# UNITED STATES PATENT AND TRADEMARK OFFICE

10/660,444

<b>Office Action Summary</b>	<b>Application No.</b> 10/660,444	<b>Applicant(s)</b> CHANDUSZKO ET AL.	
	<b>Examiner</b> DIANE YABUT	<b>Art Unit</b> 3734

## DETAILED ACTION

Fig. 103A:

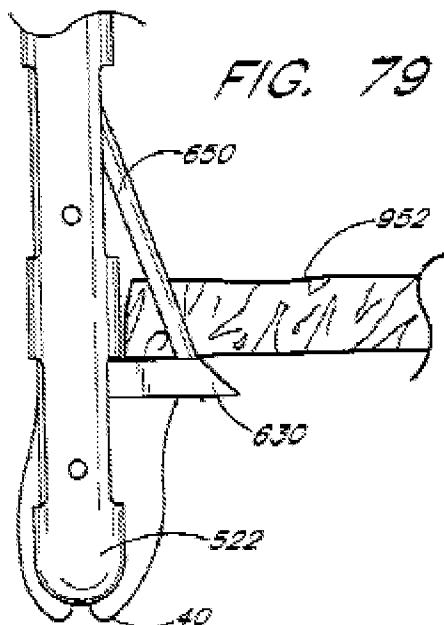
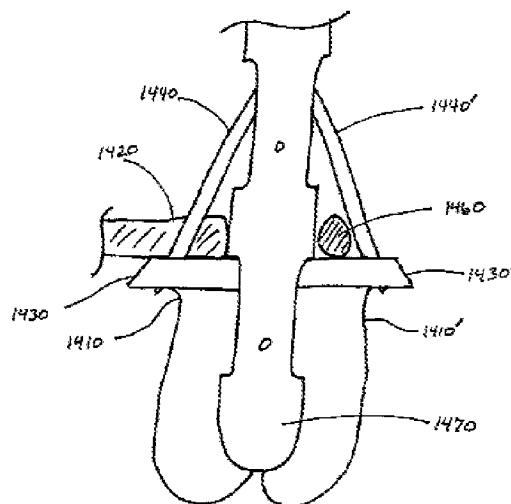
8. The applicant generally argues that Nobles does not disclose applying pressure to the suture clasp arms (the "flexible members" recited in the claims) to limit the movement of the tissue as needles simultaneously penetrate the tissue. However, in some embodiments Nobles does disclose that the suture clasp arms (**630, 1410, 1410'**) may be deployed so that they are parallel to the tissue and "provide mechanical support" to the tissue while the needles (**650, 1440, 1440'**) penetrate tissue (see kparagraphs 141 and 146, Figures 4B-4C, 14, 79-80, 103A), and therefore reads on this limitation.
